MFFFNPEm Resource

From: Gwyn, Dealis W. [DWGwyn@moxproject.com]
Sent: Tuesday, November 27, 2007 3:18 PM
To: David Tiktinsky
Subject: RE: Slides - early draft
Attachments: ACNW WSB.ppt

MFFF Waste

MFFF Waste Streams

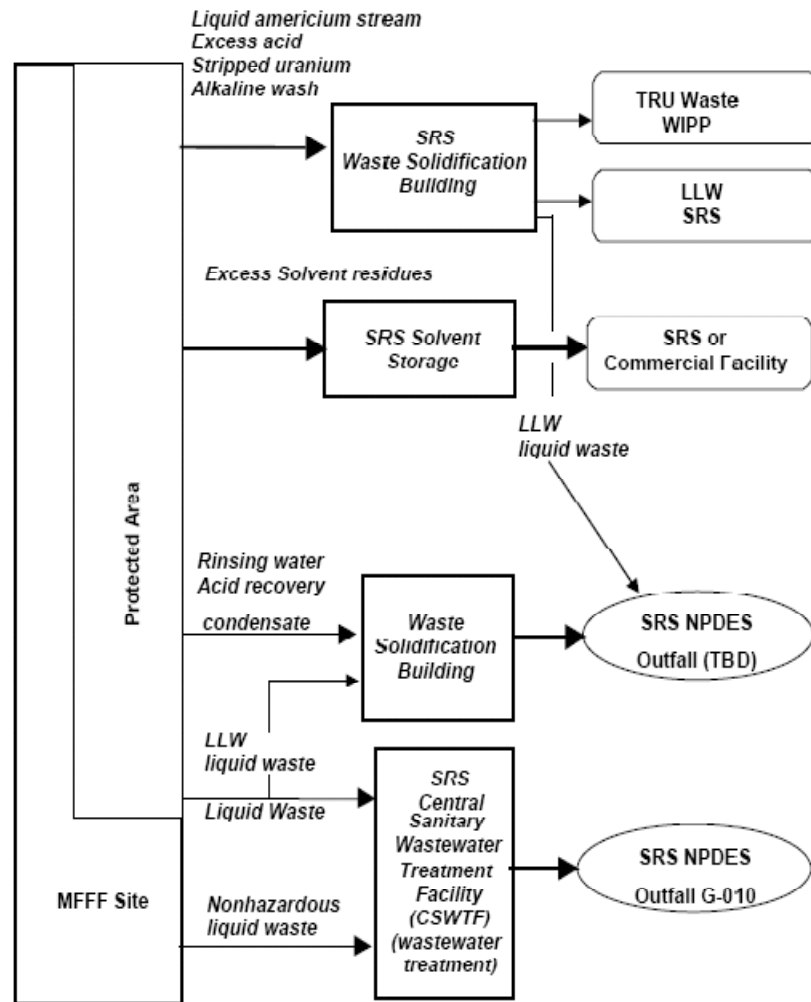
1. For the waste stream identified as LLW, is that the Chlorine waste from the AFS or the Excess solvent waste? Does the 7 day capacity you stated mean that MFFF will need to shut down within 7 days of a WSB problem (ie, the most restrictive storage issue)? The Waste stream chart shows chlorine waste going to the WSB and solvent waste going to the SRS. I would like to have a little more info on these waste streams including storage capacities.

6. Do you have the final Environmental report that include rev1-5? A pdf would be useful if you have it. Thanks.
7. Do you have a clearer copy of the waste stream chart?
